SEQUOYAH NUCLEAR PLANT - ACCEPTED VERSION OF TOPICAL REPORT
NO. 24370-TR-C-003-A, "STEAM GENERATOR COMPARTMENT ROOF
MODIFICATION"

STEAM GENERATOR COMPARTMENT ROOF MODIFICATION

TOPICAL REPORT

SUBJECT: SAFETY EVALUATION OF TVA TOPICAL REPORT NO. 24370-TR-C-003,
"STEAM GENERATOR COMPARTMENT ROOF MODIFICATION, REVISION 1"
(TAC NO. MB5387)

Figure 7-2 – Steam Generator Compartment Roof Connection Frame Layout and Connection Details

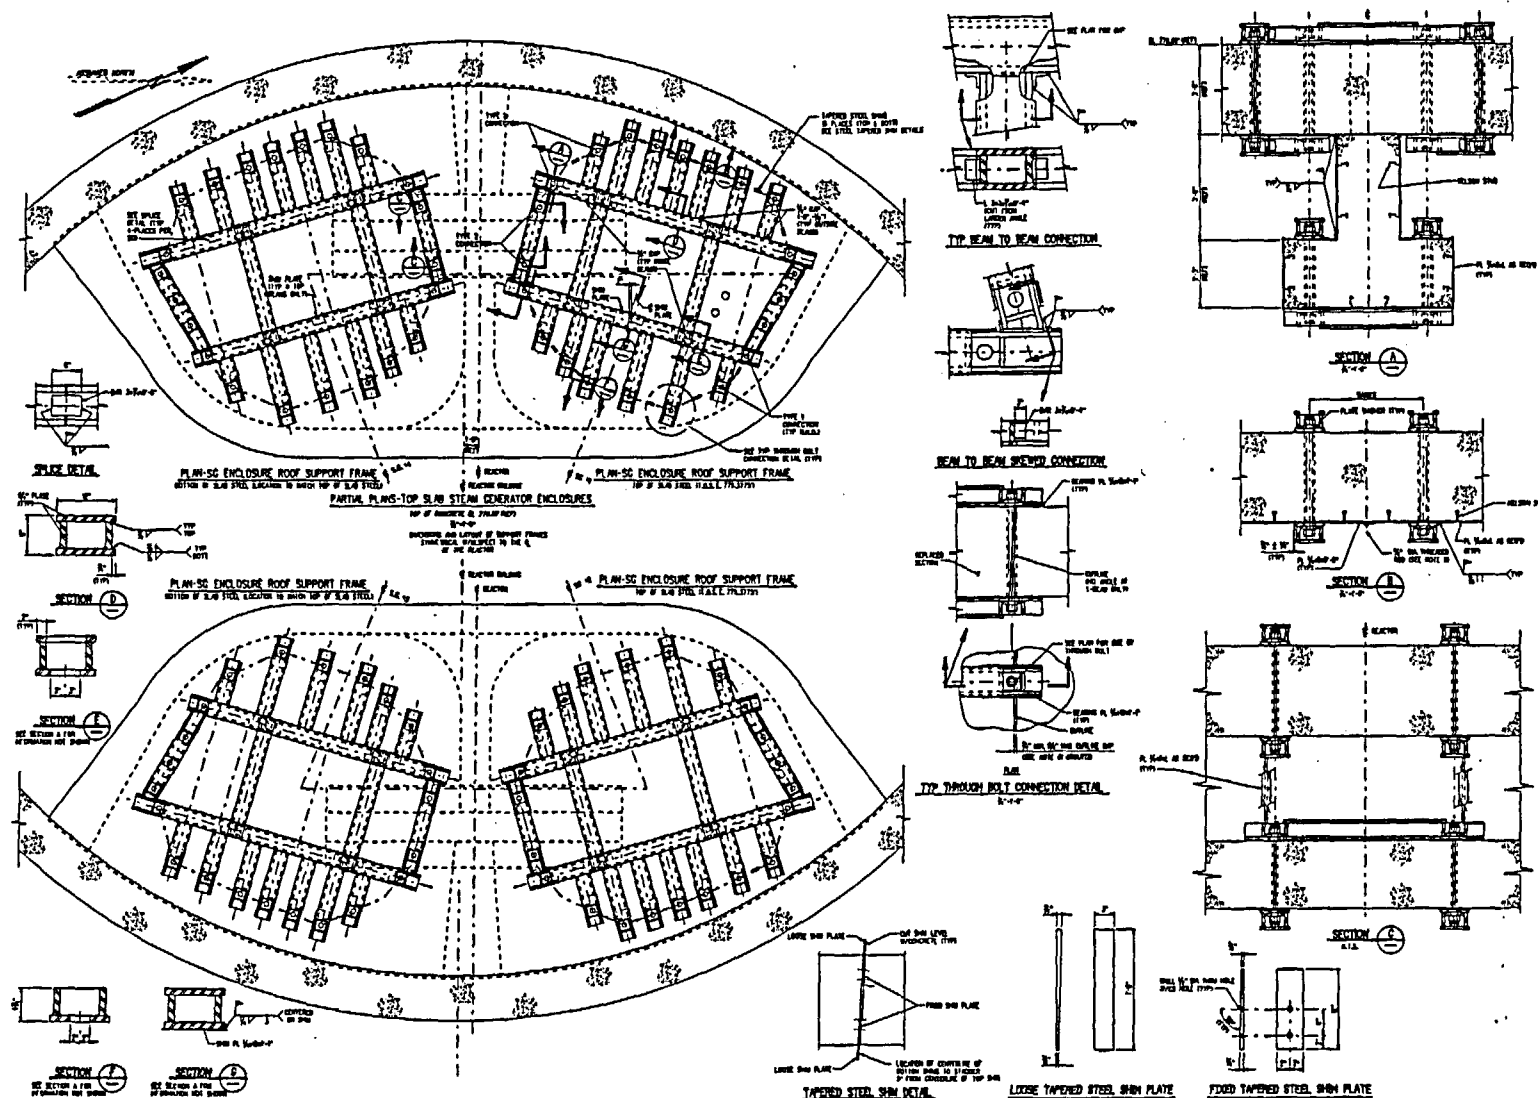
cut line. Horizontal loads generated by the horizontal seismic inertia of the cut-out portion of the concrete roof would be transferred through steel shims to the existing compartment roof concrete. The steel frames, in conjunction with the through-bolts and the steel shims, eliminate any significant movement between the cut-out portion of the concrete roof and the existing compartment roof concrete and provide a positive connection between the two. The NRC staff finds that the proposed modification method provides a positive connection between the cut-out portion of the concrete roof and the existing compartment roof concrete and is, therefore, reasonable and acceptable.

The design of the steel through-bolted connection frames and tapered steel shims documented in Reference 9 is described in Section 7.0 and shown on Figure 7-2. The through-bolts will be installed with a pre-tension load based on $0.7F_y$. Using conservative design checks, the maximum calculated bending stress in the connection frame beams and the maximum calculated bearing stress on concrete and the tapered steel shims were determined to be below allowables. The connection frame beams will be used in conjunction with the through-bolts to provide the clamping action that will transfer the vertical design basis loads from the concrete section to the compartment. The connection frame beams span over all of the connection through-bolts. Since all the connection frame beams are connected together, rigid body rotations of the beams about the bolt axes are prevented at all concrete section/compartment connections.
